PROJECT TITLE: WEST CENTRAL PLAZA-PROP. ADDITION
JOB NO.: 2013064
DRAWN BY: JTW
PROJECT MANAGER: JEFF WOOTEN
SHEET TITLE: CONCEPTUAL GRADING PLAN

WEST CENTRAL PLAZA - PROP. ADDITION
4208 CENTRAL AVE. SW
ALBUQUERQUE NEW MEXICO

DRAINAGE MANAGEMENT PLAN

| SHEET TITLE DRAINAGE MANAGEMENT PLAN | | DATE 3/28/2016 | |

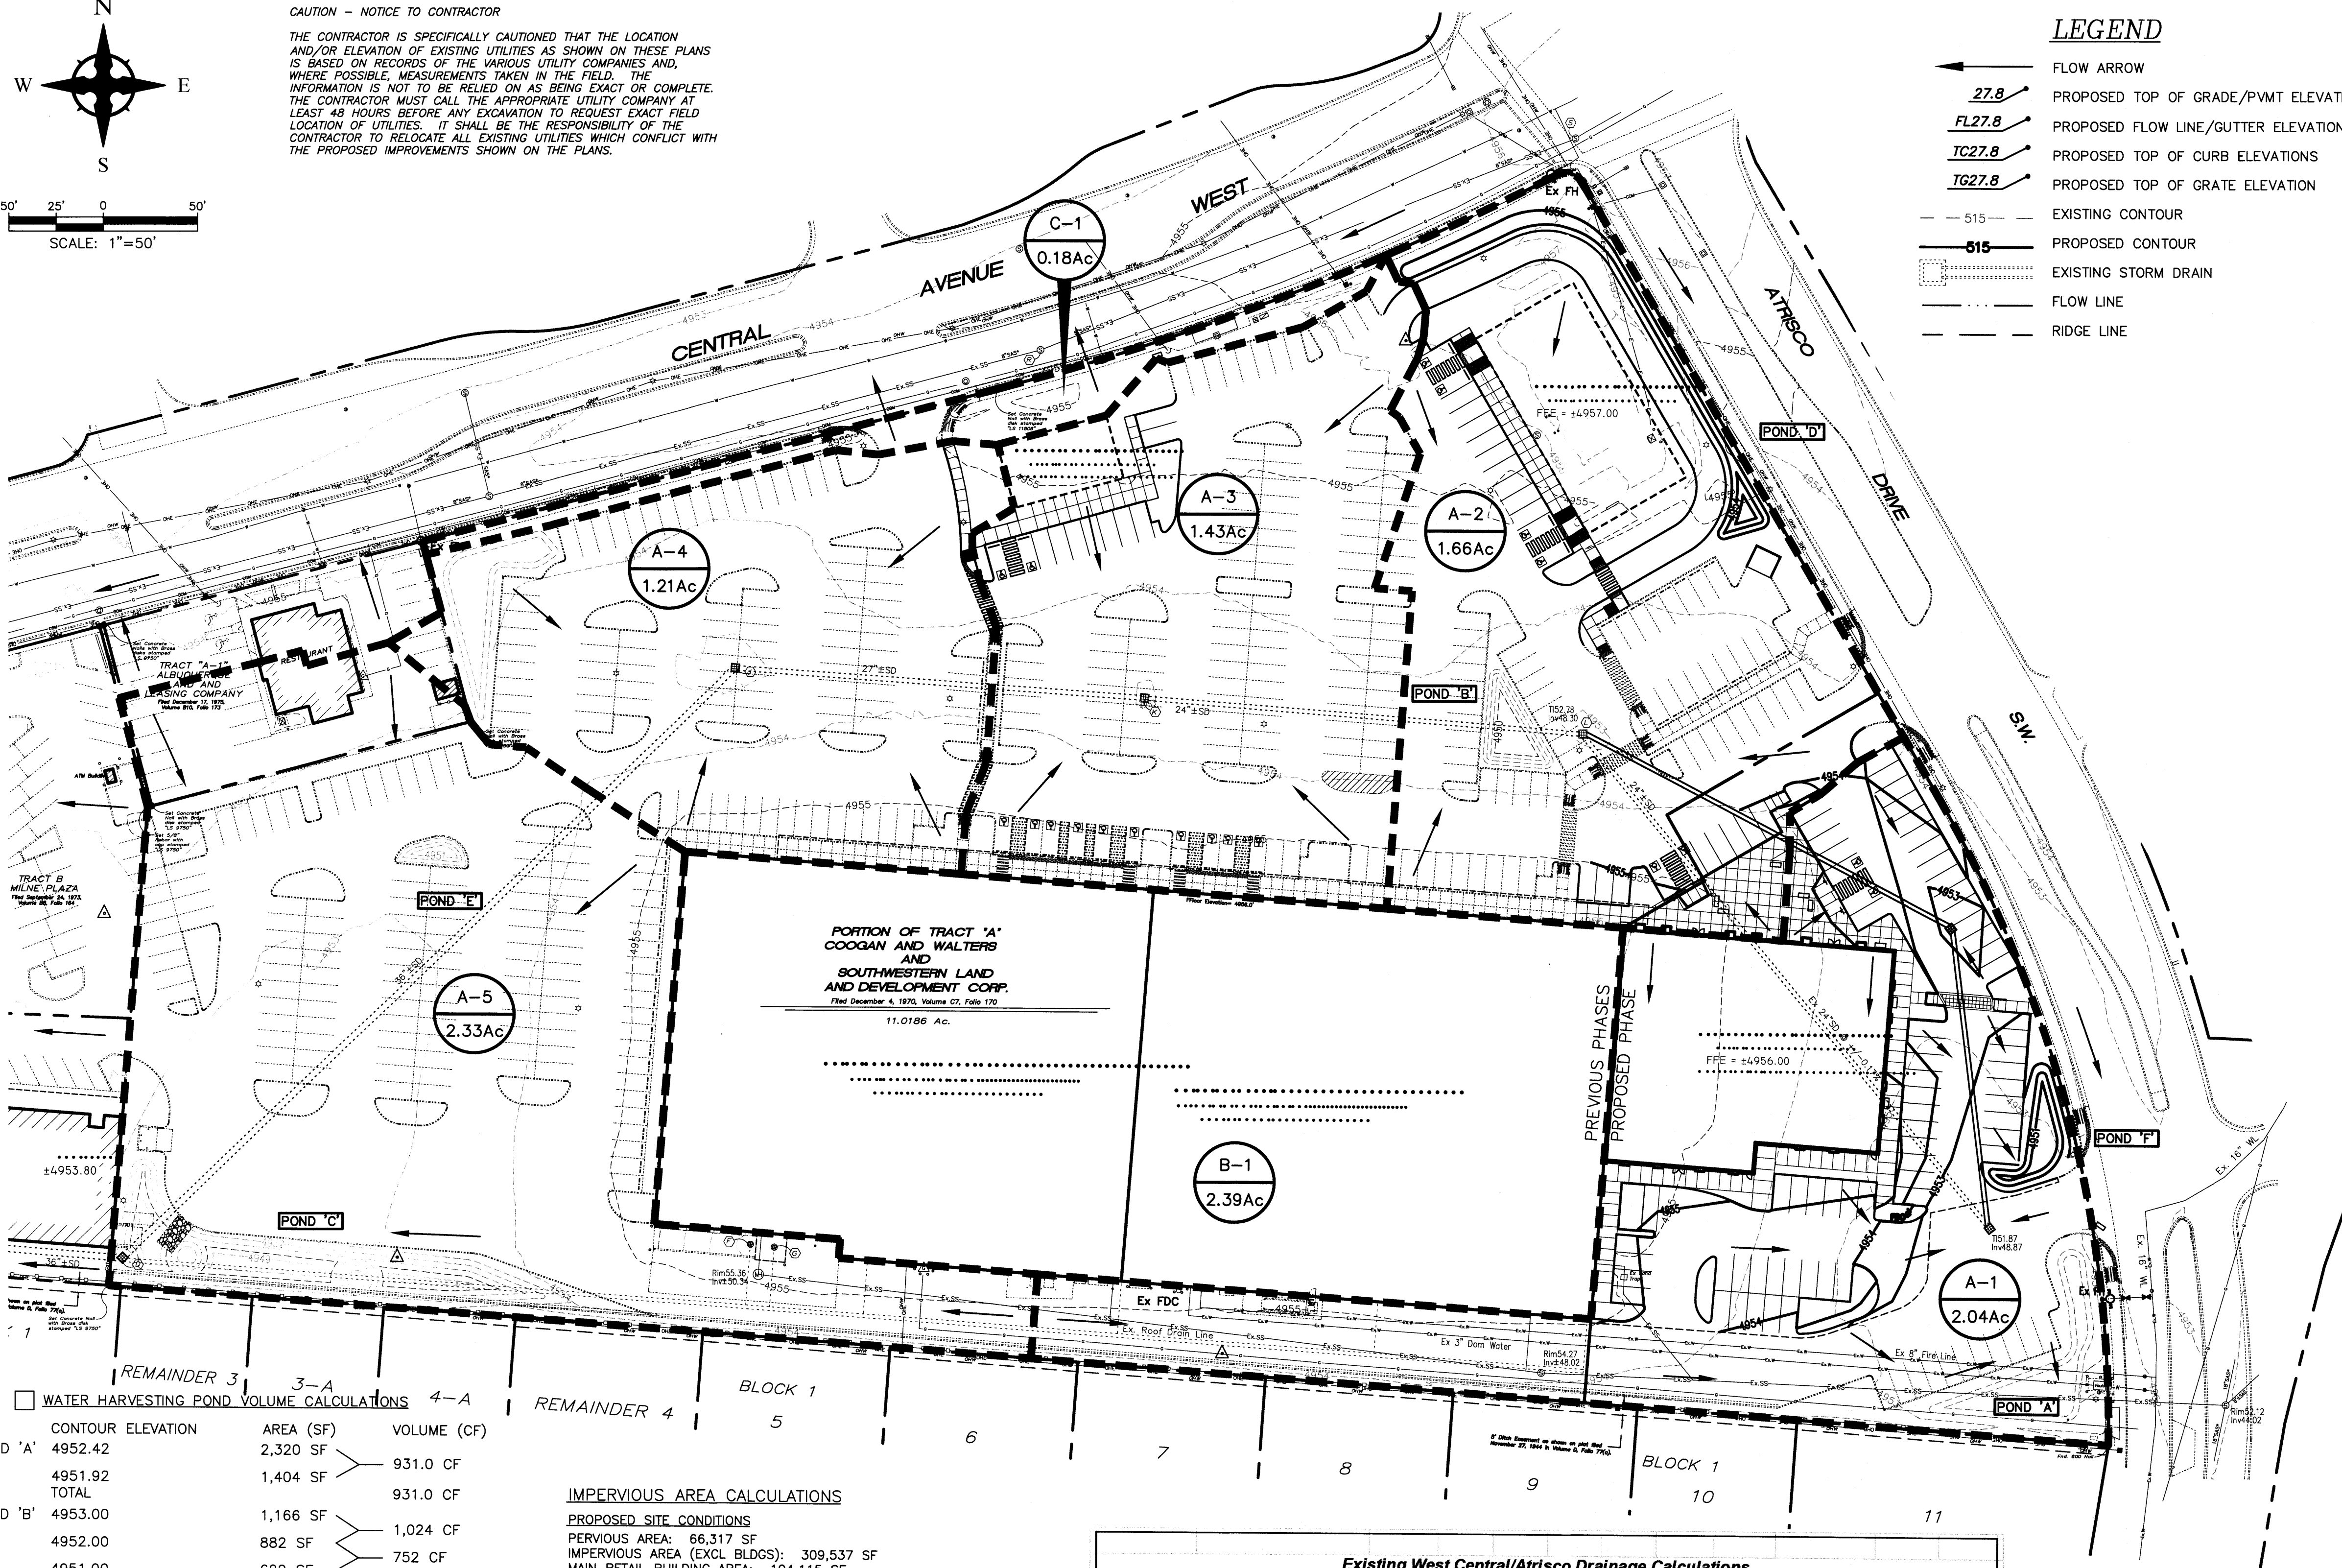
On the certification, please ensure that the land treatments in the proposed conclusion reflect the actual land treatment distribution. For example, Basin B-1 is assumed to be 13.4% C and 86.4% D, but it should be 100% D. This does the minor discrepancy does not appear to affect the sizing of the facilities, however.
